STAFF REPORT  
(ONE-STEP FINAL PLAT)

**CASE NUMBER:** SUB 2002-70 -- THE EXECUTIVE AT WHITE TAIL ADDITION

**LOCATION:** Southeast corner of K-96 and 13th St. North

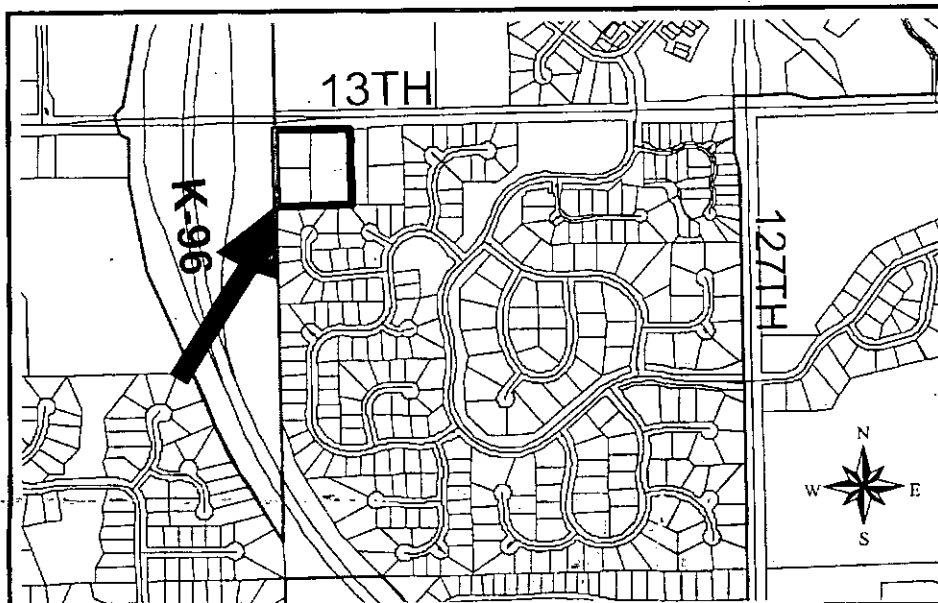
*WSL along 13<sup>th</sup>  
KDOT approval on drainage  
Drainage guarantee is  
needed.*
